**WALLARAH 2 COAL PROJECT – AMENDMENT TO SSD-4974**  
**RESPONSE TO DP&E QUERIES OVER PAC2 REVIEW REPORT**  
*for*  
**Wyong Areas Coal Joint Venture**

This document responds to a letter from the Department of Planning & Environment (DP&E) dated 30 June 2017 in relation to the Wallarrah 2 Coal Project, as Amended (the Project).

The DP&E letter requested a response to four items in relation to the Second Planning Assessment Commission Review Report dated 19 May 2017 (PAC2 Report) on:

FIGURE 1

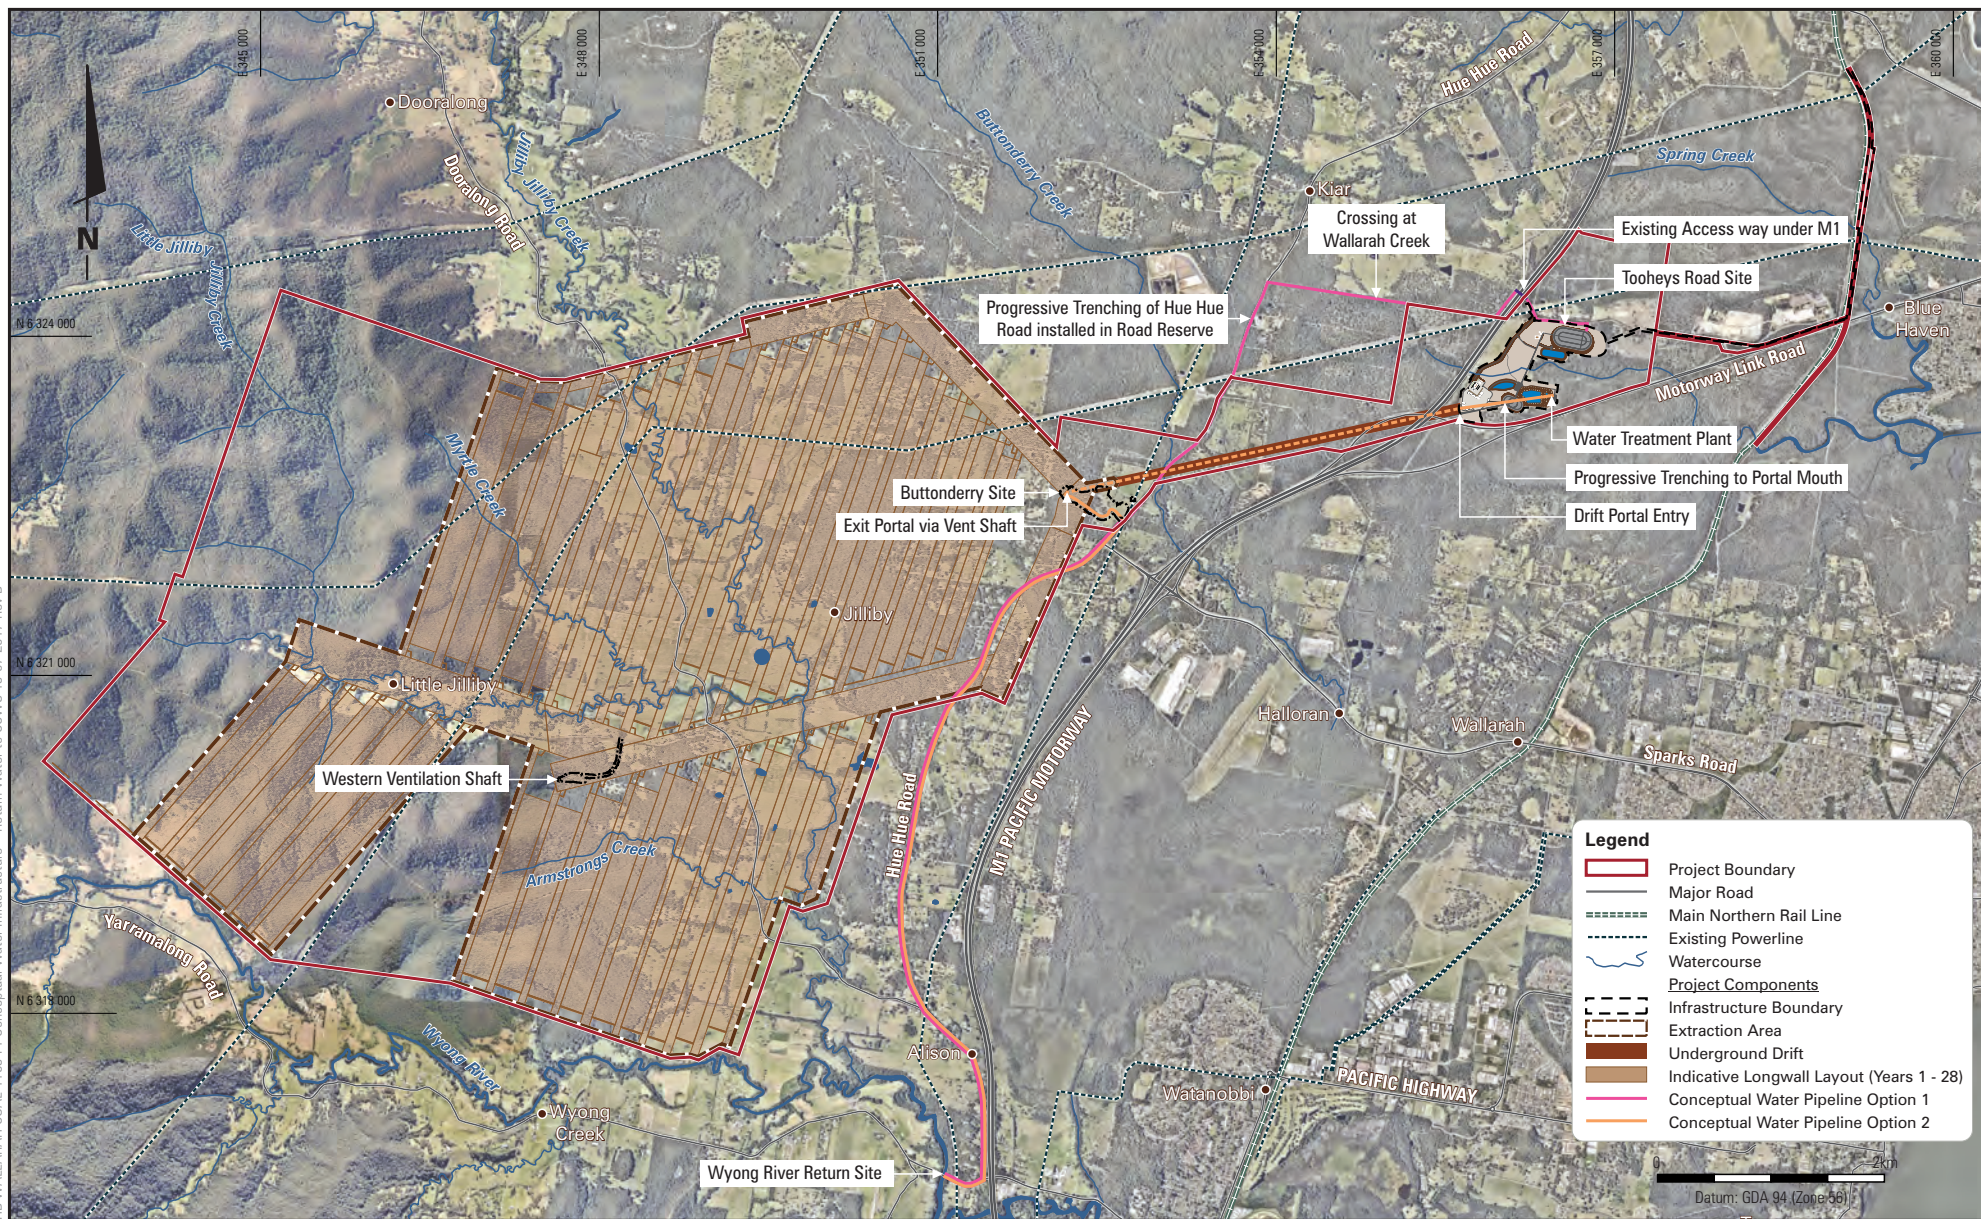
1a) Please provide a detailed description of the options being considered to satisfy the Commission’s recommendation of “no net impact on potential catchment yield and the preferred compensation mechanism is by return of sufficient treated water to the catchment side of the water supply system”, including:

- Water treatment options and plant locations;
- Water treatment pipeline(s) options (i.e. underground and/or over ground) and routes;
- Potential water transfer access points into the Central Coast Water Supply System;
- Timing for the construction and implementation of the water treatment and transfer system; and
- Costs of implementation of the system options, and implications to the overall project CIV.

**Figure 1** conceptually illustrates the two potential alignments however the final alignment will be subject to detailed design following additional consultation with relevant regulators:

- **Option 1** – From the WTP at Tooheys Road site, west across WACJV owned land, then via Hue Hue Road. The location for the water to be deposited is at Woodbury's Bridge on Yarramalong Road. This site is upstream of the Council's Existing Wyong River Raw Water Pumping Station Extraction Point which directs water to the Mardi Dam; and
- **Option 2** – From the WTP at Tooheys Road site, underground via the portal, surfacing at Buttonderry Site, then via Hue Hue Road. The location for the water to be deposited is at Woodbury's Bridge on Yarramalong Road. This site is upstream of the Council's Existing Wyong River Raw Water Pumping Station Extraction Point which directs water to the Mardi Dam.

Option 2 is WACJV's preferred model.

**Figure 1** particularly shows:

- Water treatment options and plant locations;
- Water treatment pipeline(s) options (i.e. underground and/or over ground) and routes; and
- Potential water transfer access points into the Central Coast Water Supply System.

Figure 1 - Wallarah Coal Project – Proximity to Water Supply Weir and Key Features

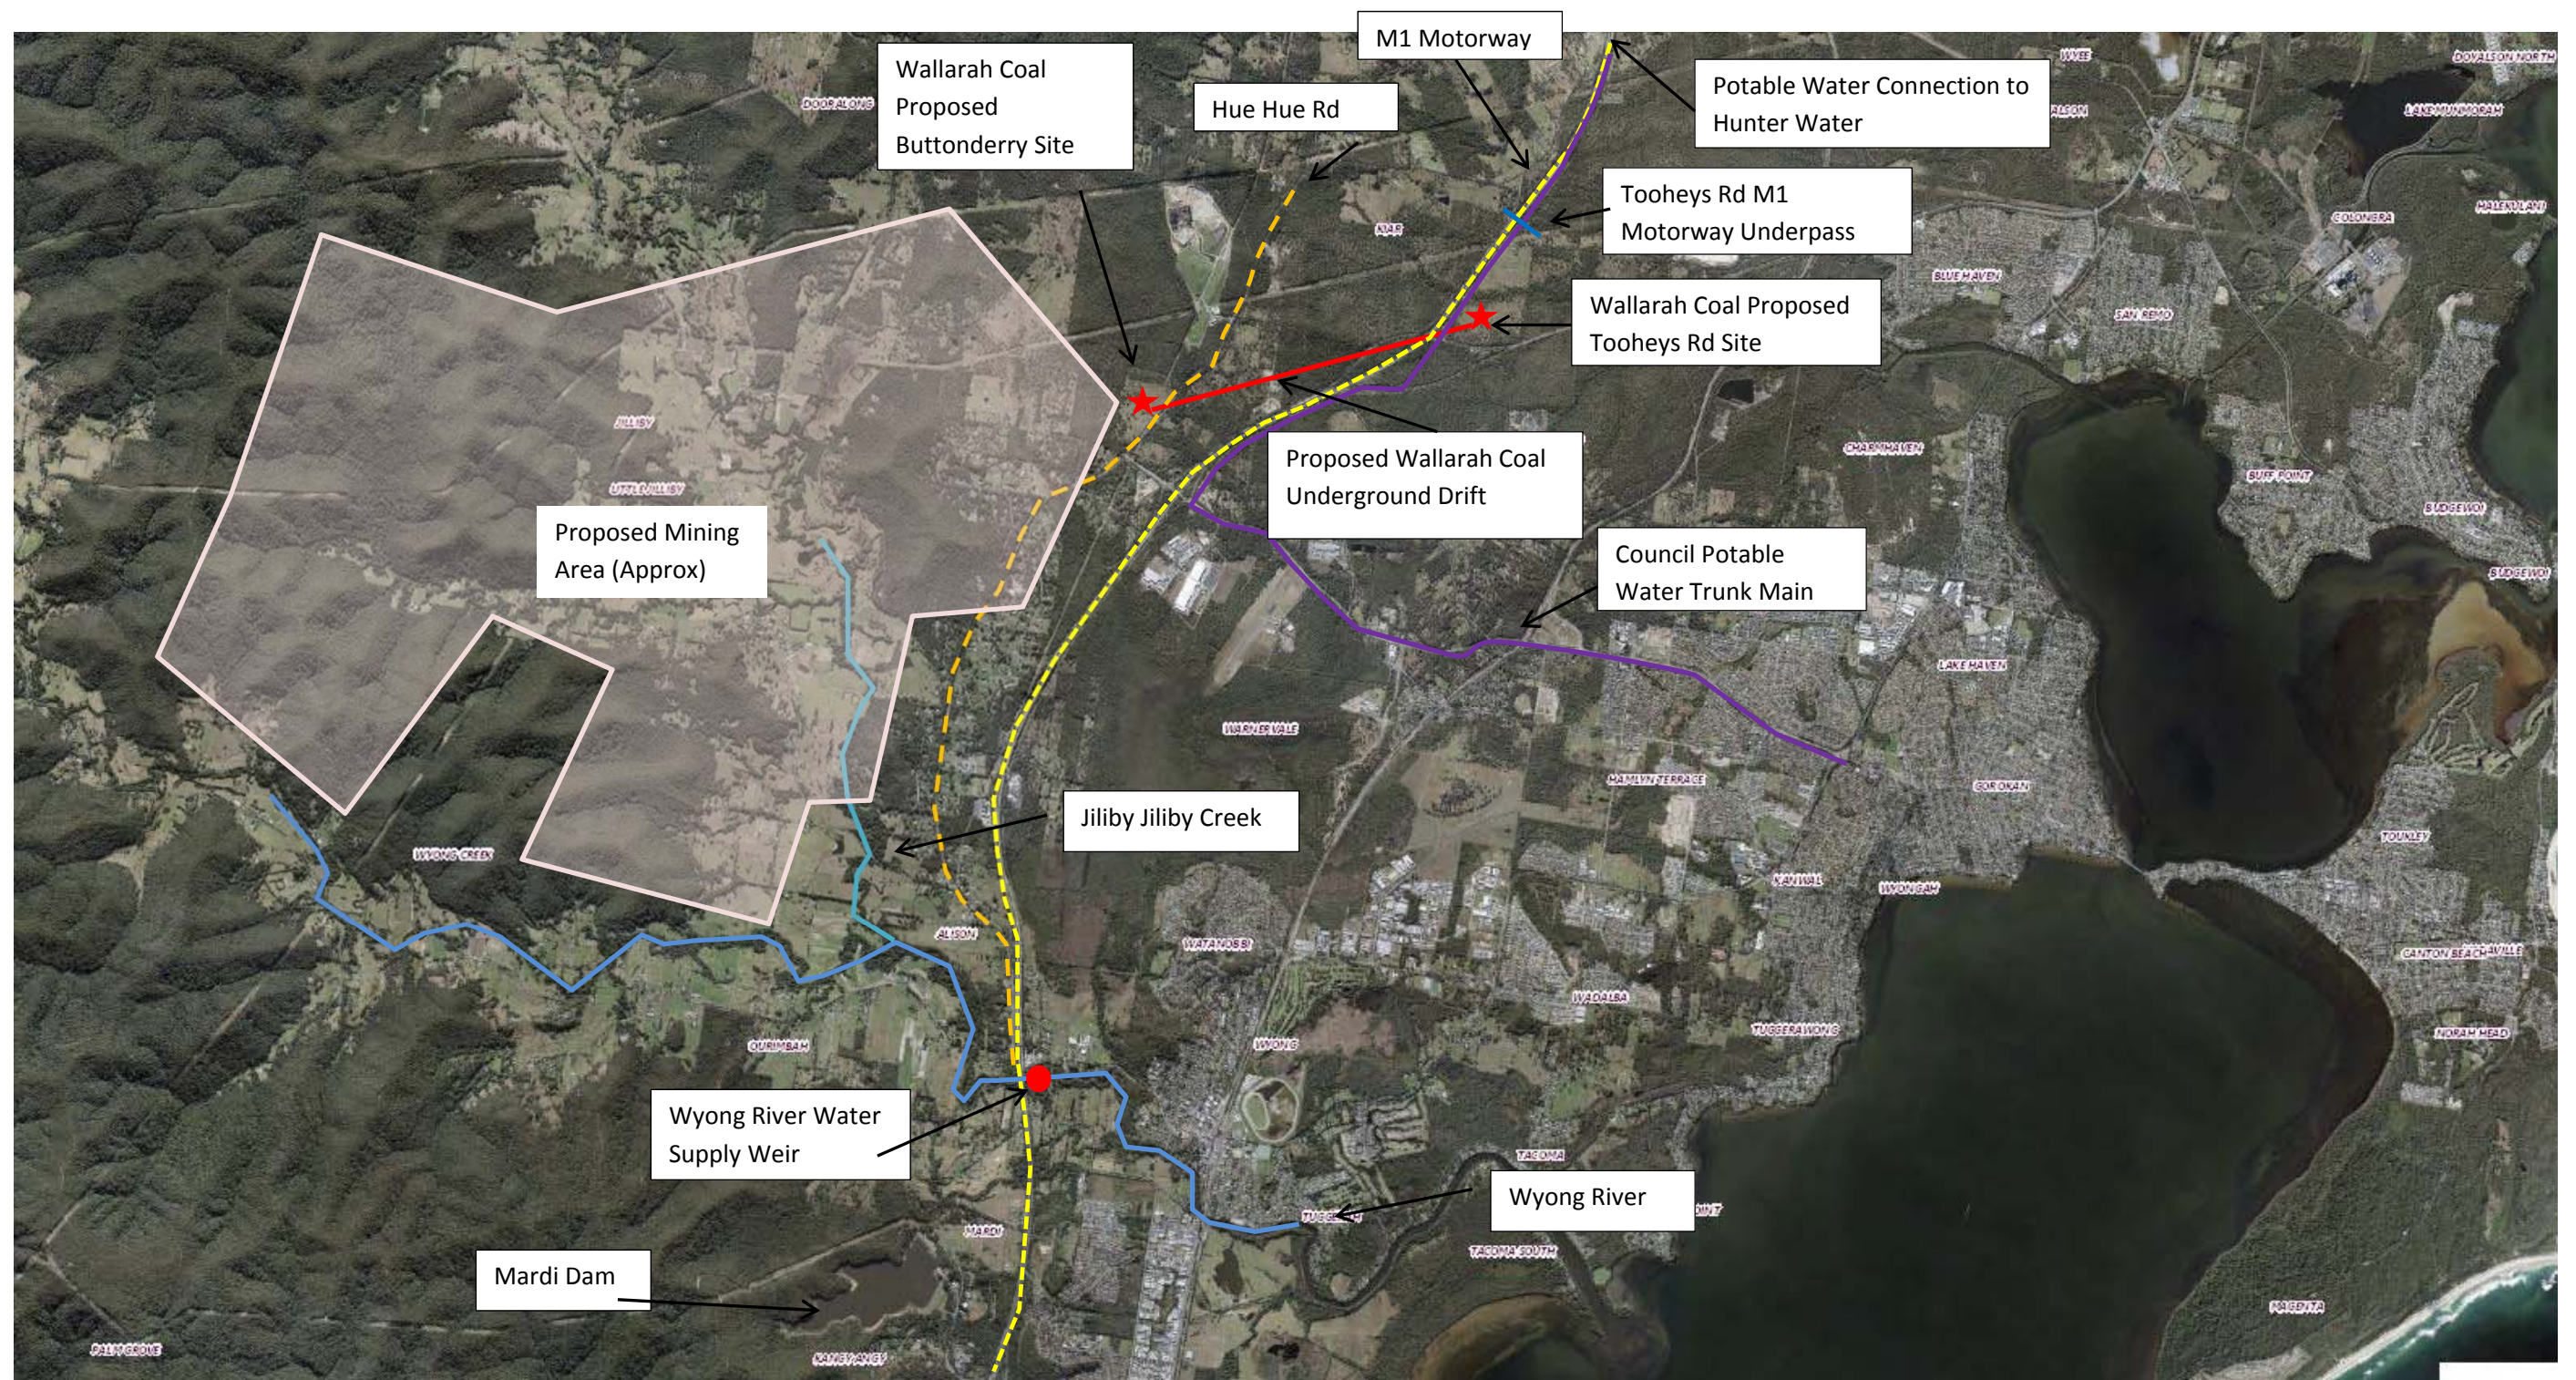
1. Treated water (including pH correction) will be returned to the location indicated on the attached sketch.
2. Mine will provide adequate storage to ensure water can be delivered at a pre-agreed rate to match supply and environment demands.
3. Monitoring of key parameters as determined by Council will be provided upstream and downstream of the nominated discharge point.
4. The pipeline route will follow Hue Hue Road.
5. Operating rules will be jointly developed to match demand.
6. All infrastructure will be integrated into Council's SCADA and monitoring systems.
